Construction Division
Additions & Alteration Charges Approval Form

Company Name:	MRMLLP	Site	Gulmohar Residency
Name of the customer	A. Sudheer & Archana		
Villa/ Flat No.	D-402		
Sl.No	Description	Amount	
1	Total extra Charges	-	
2	Total refundable amount	4180	
3	Net amount to be charges (if any)	-	
4	Net amount to be refunded (if any)	4180

Sy. No. 19, Mallapur Village, Uppal, Hyderabad.
Owned & Developed by: M/s. Modi Realty Mallapur LLP.
Head office: 5-4-187/3&4 M G Road Secunderabad.

Details of Additions & Alterations

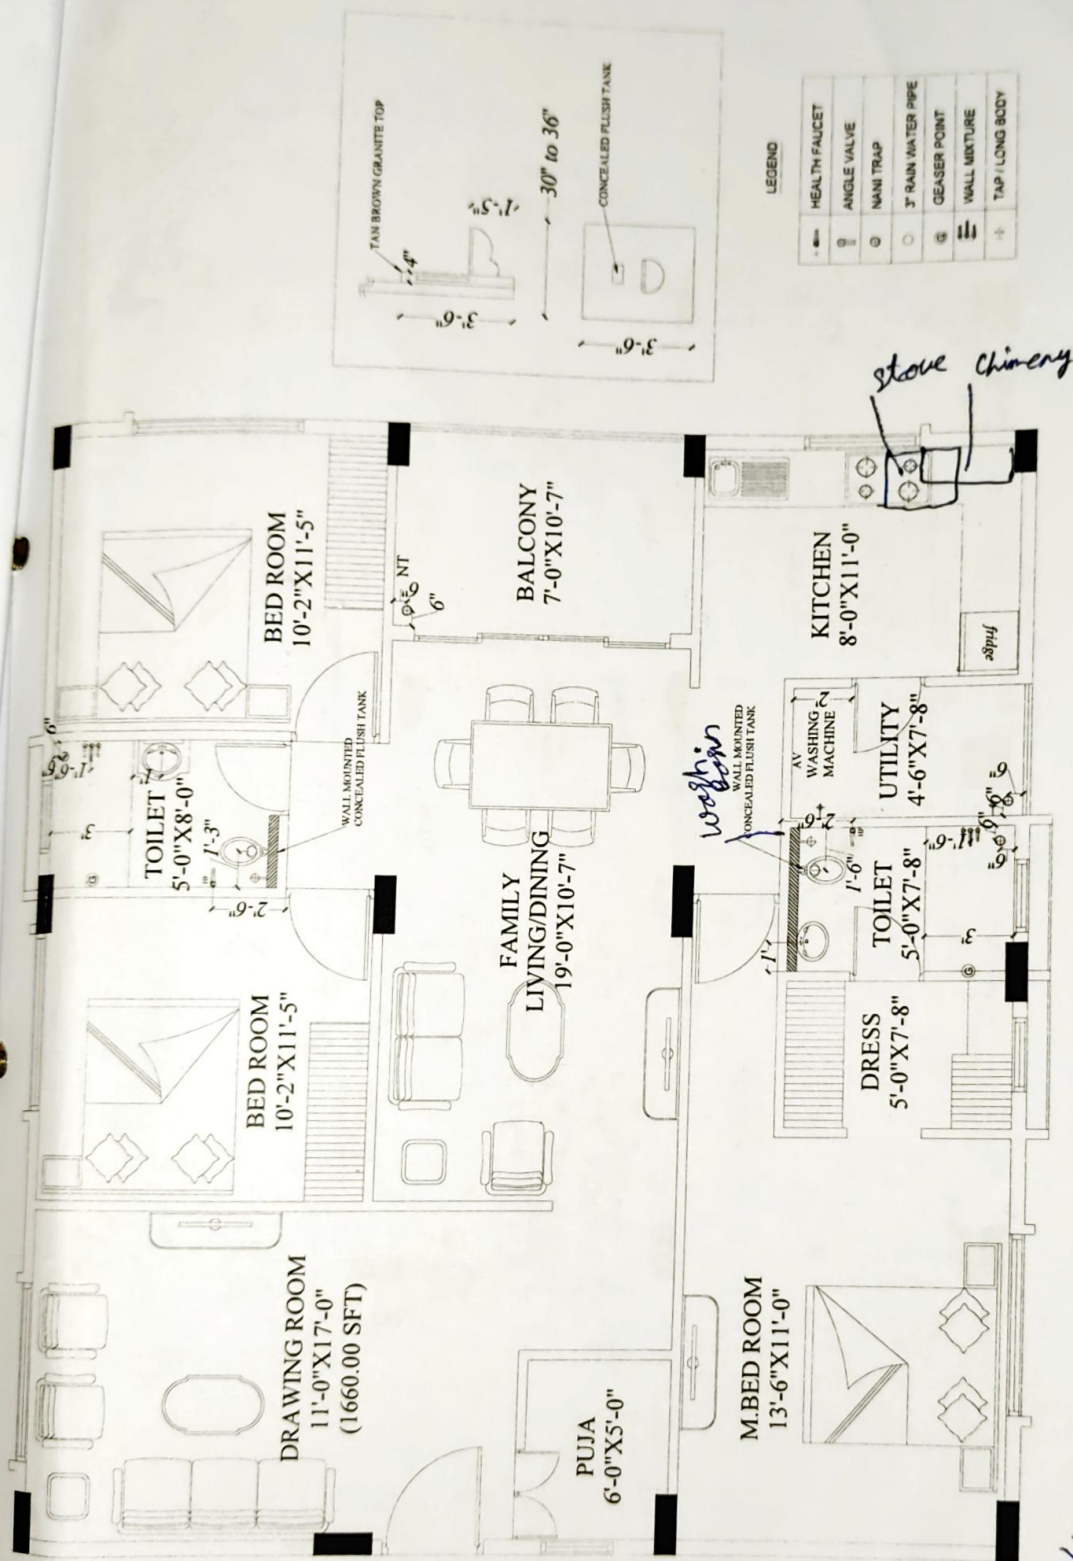
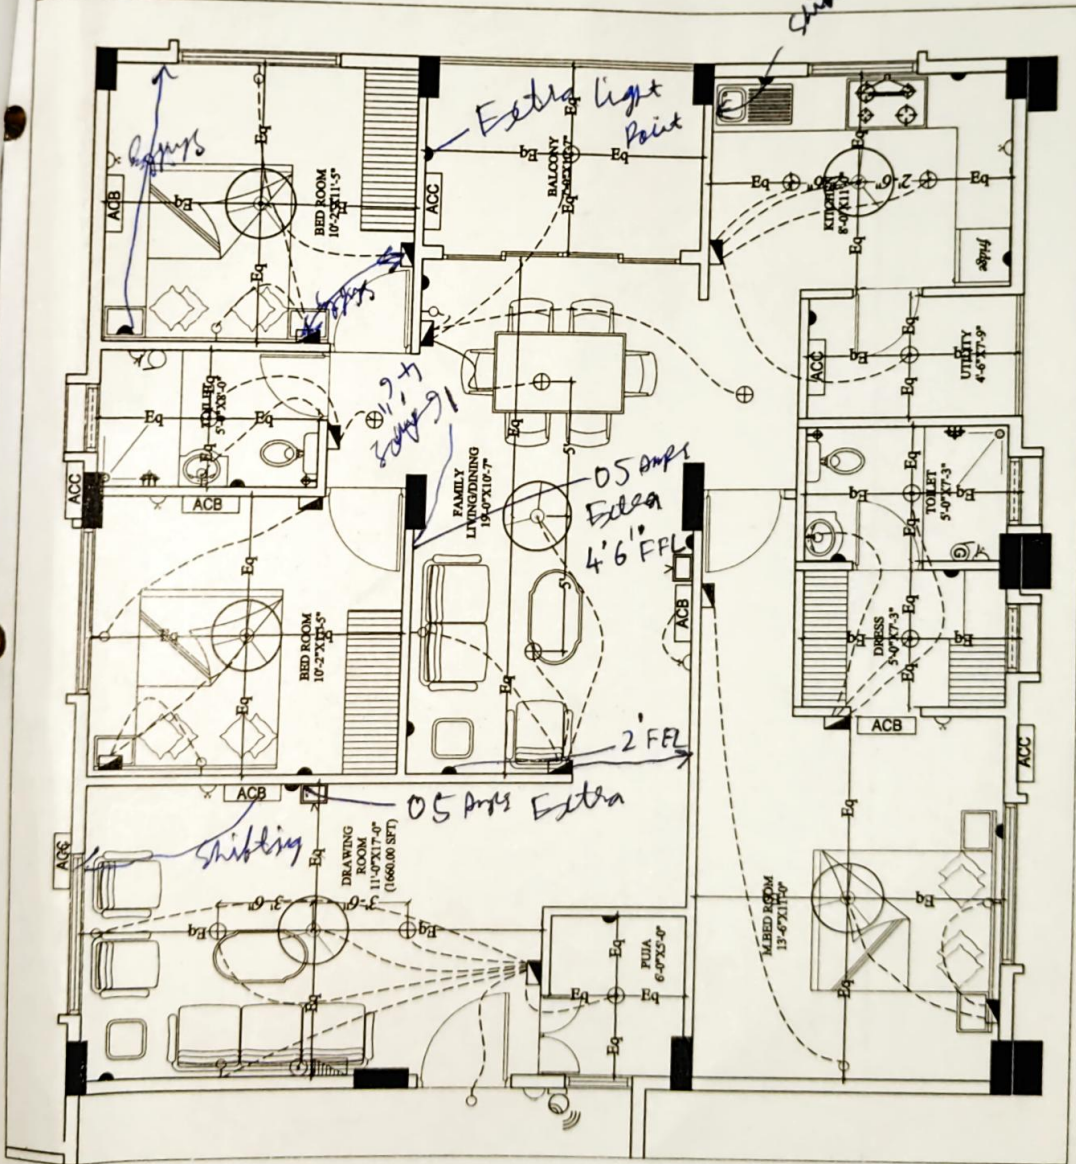
Changes in electrical points: (mark on plan)

1) As per plan changes.

Changes in kitchen platform: (mark on plan)

- 1) modular kitchen chimney shifting as per plan
- 2) stone point shifting 1' as per plan
- 3) fridge opening 2'6" at kitchen
- 4) kitchen sink as per model flat B-104 need

Other Changes:

- 1) False ceiling as per B-Block Plan no. 105
